Addendum #1

City of Parksville – Section B Roof Replacement

Project # C1031824G

April 16, 2024

Pitch Pockets: See detail below.

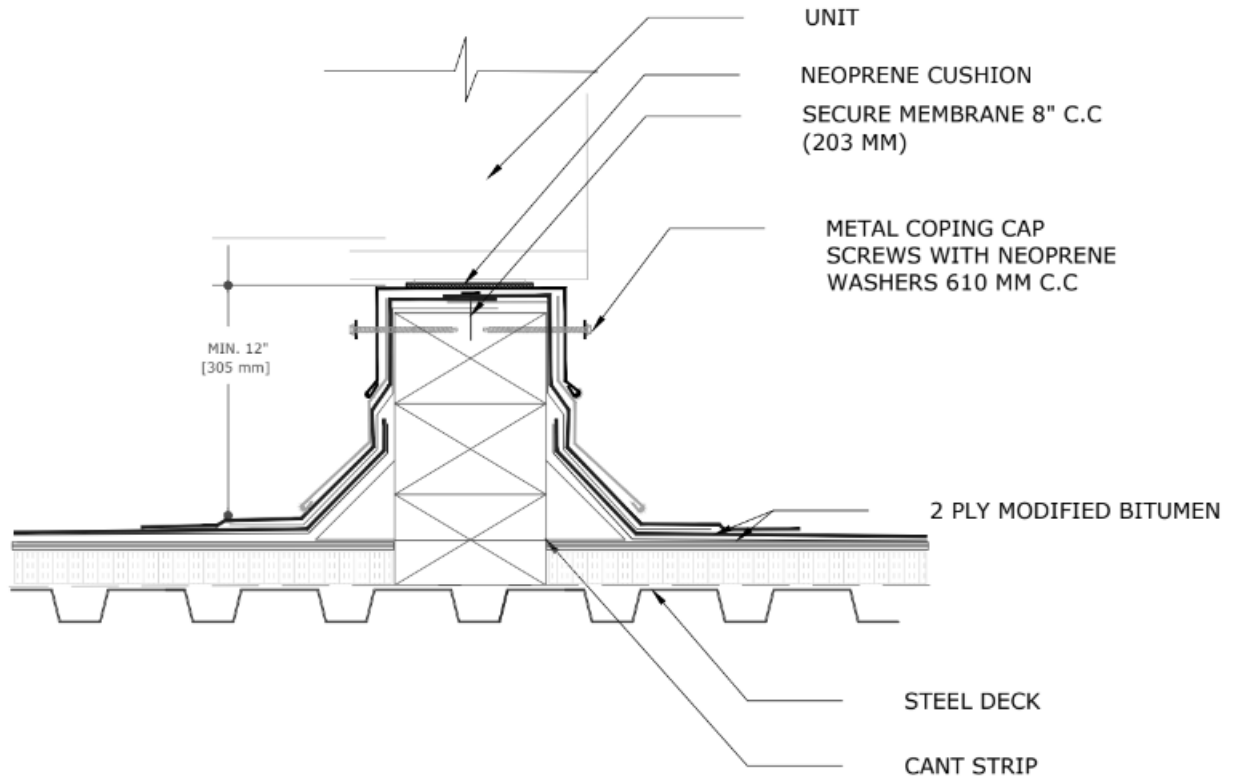
Item #2: Antenna tower will be removed from job site by City prior to commencing roof replacement project. The three anchors and new pitch pockets will be installed by Contractor (see page 2 for pitch pocket detail). The three anchors will be replaced with Thaler FARA -33 “Swivel Eye”, Fall Arrest, Roof Anchor, (bolt around beam).
